Linked NSIP (LINCS Reservoir, planned water supply for approx. 500,000 people) Not Being Considered in ES, EIA, cumulative and in-combination effects.

Verbal submission made and further supporting information

LINCS Reservoir plans

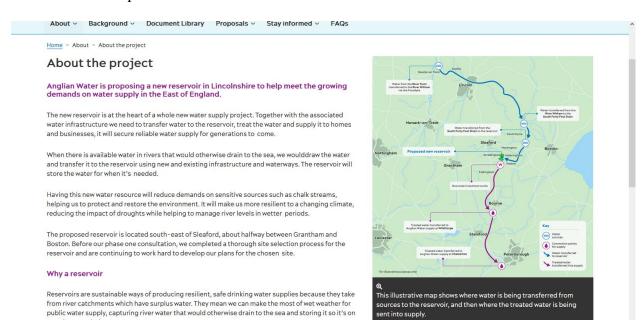
The One Earth Solar Farm application sits across a designated **Drinking Water Protected Area**, which feeds directly into the **River Trent**. Just 2.5 miles downstream, water from that same stretch of the Trent is planned to be transferred via the **Fossdyke and the River Witham** to supply the new **LINCS Reservoir**, located south-east of Sleaford.

We would also like to note that a review of the publicly available One Earth Solar Farm application documents shows **no explicit reference** to the LINCS Reservoir or its abstraction of water via the Foss Dyke / River Witham. In particular:

- Chapter 7: Hydrology & Hydrogeology assesses local rivers and watercourses but limits its study area to a 1 km buffer around the site and does not consider downstream abstraction infrastructure.
- Appendix 7.4: Water Framework Directive Screening Assessment concludes no impact to waterbodies but makes no mention of the LINCS Reservoir or linked abstraction points.
- Chapter 18: Cumulative Effects and Appendix 18.2: Long List of Other Developments list many local and regional projects, but there is no entry for the proposed LINCS Reservoir or comparable downstream water supply infrastructure.

This absence suggests that the potential cumulative and hydrological link between OESF and the LINCS Reservoir has not been explicitly assessed or disclosed in the ES.

We therefore respectfully ask that the **Examining Authority** seek clarification from both the **Environment Agency** and **Anglian Water** on this issue, and consider whether it would be appropriate to involve **Defra** and the **Drinking Water Inspectorate** — given their statutory responsibilities for drinking water safety and water resources.

The One Earth Solar Farm Application Site, and extraction point just 2.5kms downstream

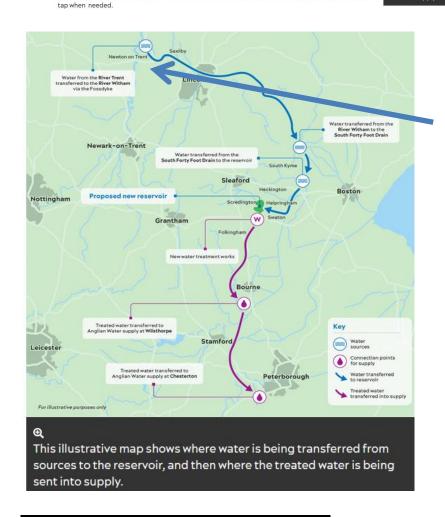
There is also the very real issue of potential pollution — whether from the **construction and operation** of the One Earth Solar Farm itself, or, more seriously, in the event of a **large-scale Battery Energy Storage System (BESS) fire**, which could release toxic substances into the soil and

watercourses feeding the Trent. Such contamination could then travel downstream into the Fossdyke and Witham, ultimately impacting the proposed LINCS Reservoir's future water supply.
